SUBJECT: AMENDMENT NO. 100 TO FACILITY OPERATING LICENSE NO. DPR-43
(TAC NO. M81081)

KEWAUNEE NUCLEAR POWER PLANT

Amendment No. 100
License No. DPR-43

ATTACHMENT TO LICENSE AMENDMENT NO. 100

FIGURE TS 3.1-3

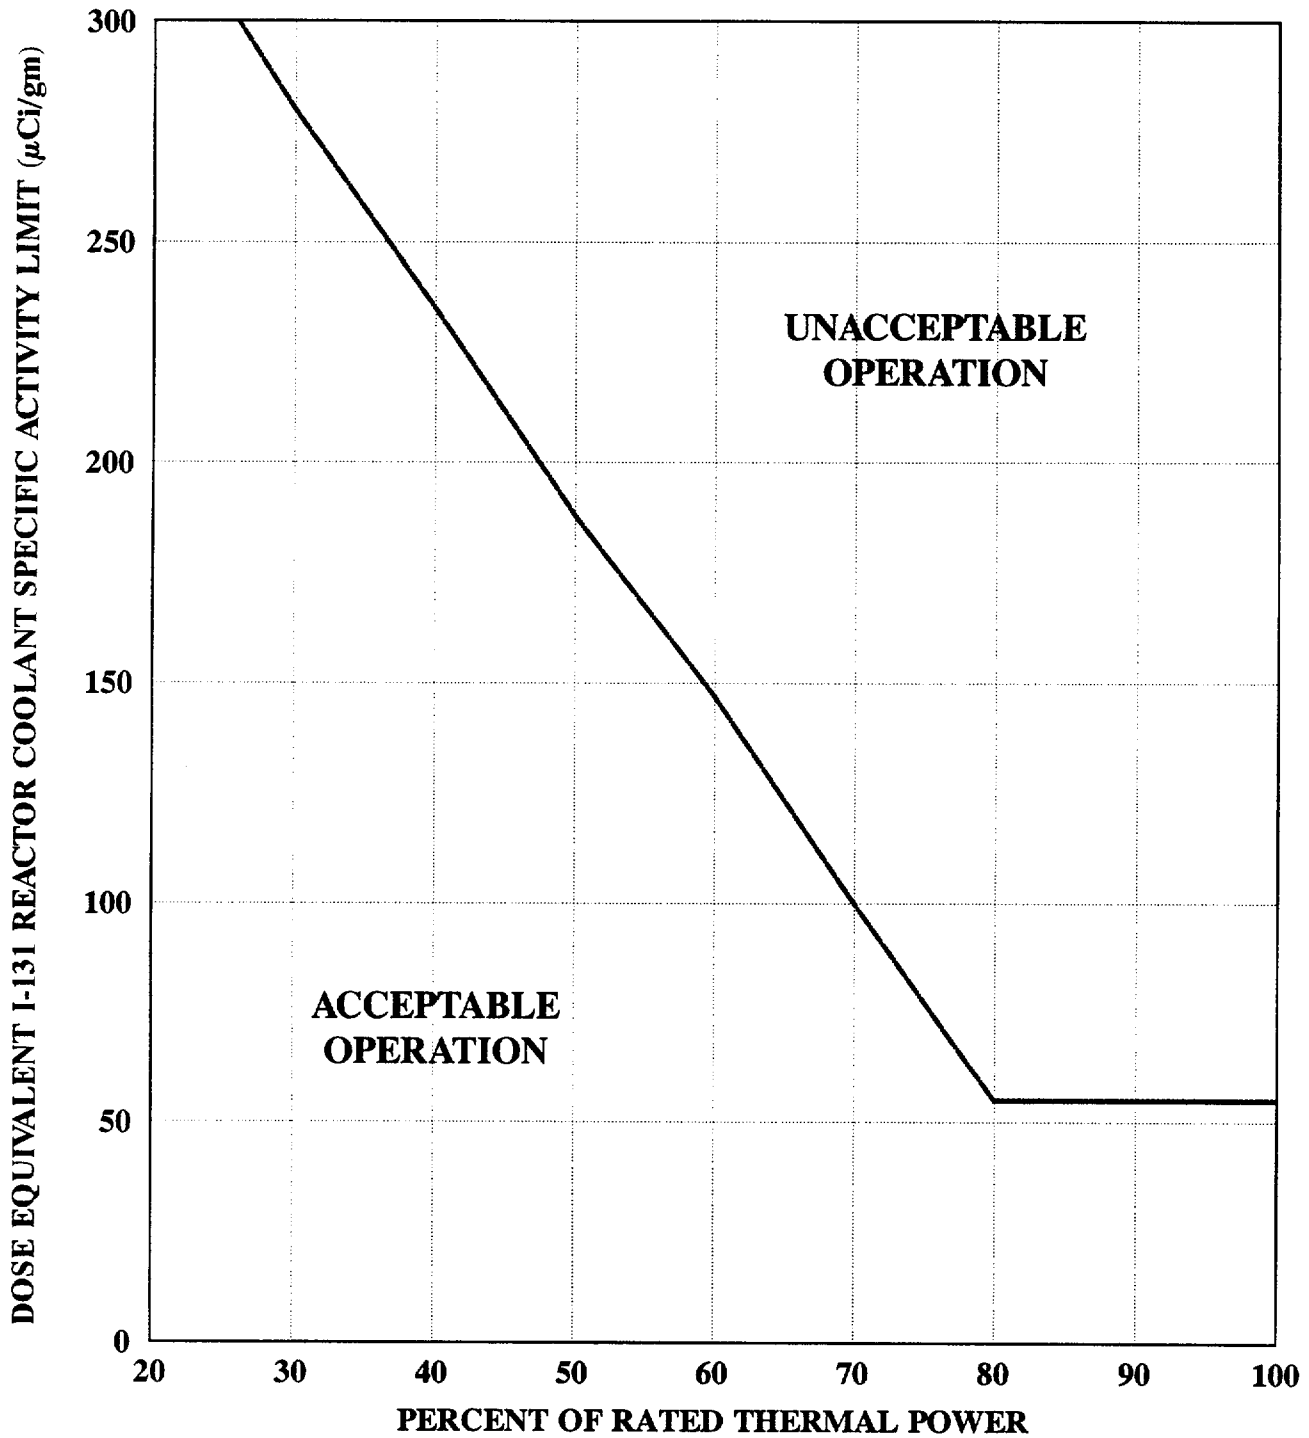
A. With the specific activity of the reactor coolant $> 1 \mu\text{Ci}/\text{gram DOSE EQUIVALENT I-131}$ for more than 48 hours during one continuous time interval, or exceeding the limit shown on Figure TS 3.1-3, be in at least INTERMEDIATE SHUTDOWN with an average coolant temperature of $< 500^\circ\text{F}$ within 6 hours.

The action statement permitting power operation to continue for limited time periods with reactor coolant specific activity > 1 μ Ci/grams DOSE EQUIVALENT I-131, but within the allowable limit shown in Figure TS 3.1-3, accommodates the possible iodine spiking phenomenon which may occur following changes in thermal power.

placing of the plant in at least INTERMEDIATE SHUTDOWN with an average coolant temperature of less than 500°F within 6 hours if the DOSE EQUIVALENT I-131 is greater than 1 $\mu\text{Ci/g}$ for more than 48 hours during one continuous time interval or exceeds the limit line shown on TS Figure 3.1-3. This Figure is identical to Figure 3.4-1 in the Westinghouse STS.
